DETAIL A
SCALE 1 / 2

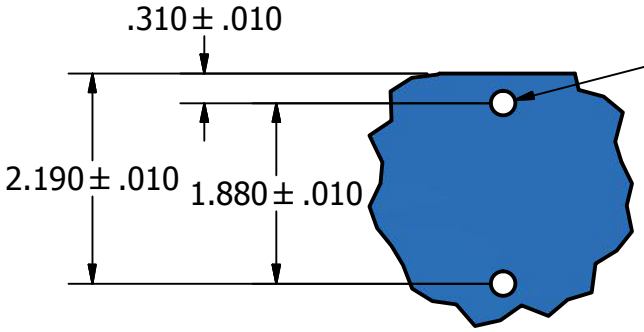
These bolt holes are for 1/4-20 through holes for the McMaster cylinder supports. They should be 0.266 +/- 0.010 - but I can't seem to make Inventor understand that.

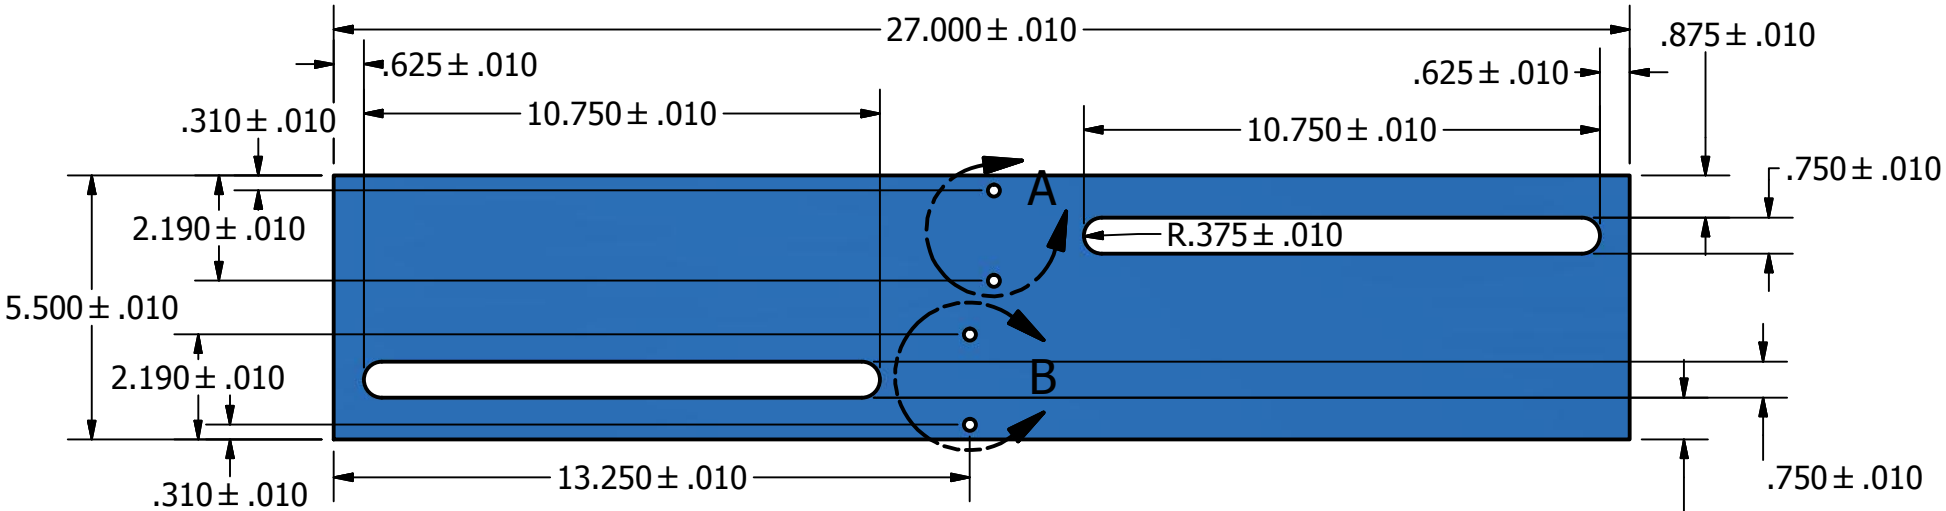
All radius of the outside edges of the slots are the same.
